**Subject:** Planning Application Objection 2014/7108/P The Athenaeum,  
Vale of Health

I wish to object to planning application 2014/7108/P (Installation of an air conditioner condenser on the balcony). I live in the Vale of Health close to the Athenaeum in a house whose only outdoor space is a terrace close to the balcony in question.

## 6 Dimensional drawing & centre of gravity

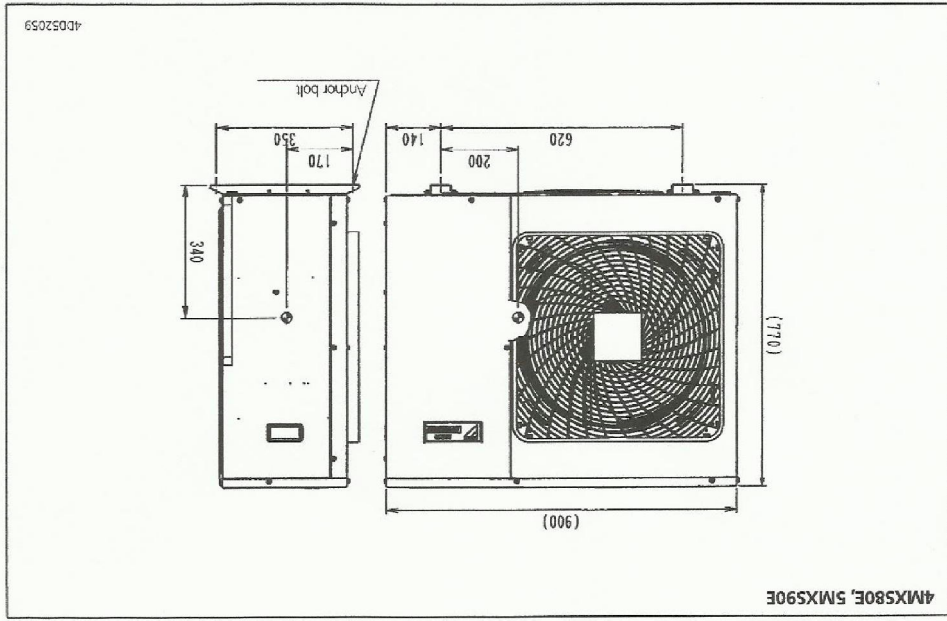
You will note that the balcony of flat 3 appears to have railings. Those railing were replaced by glass some 2 years ago. Equally the applicants are in the process of replacing their railings with clear glass. The unit which is shown on the manufacturer's drawings is large (over 900mm by 770mm) and ugly. No attempt was made to give a clear picture of what it will look like in situ. It will be highly visible from the Heath. All this casts doubt on the overall fairness of the report. In this connection I have seen the objection sent by Alice Adams in which she suggests that Camden should use its power to commission an independent report at the applicant's expense and this seem to me to be a fair way of dealing with the matter.
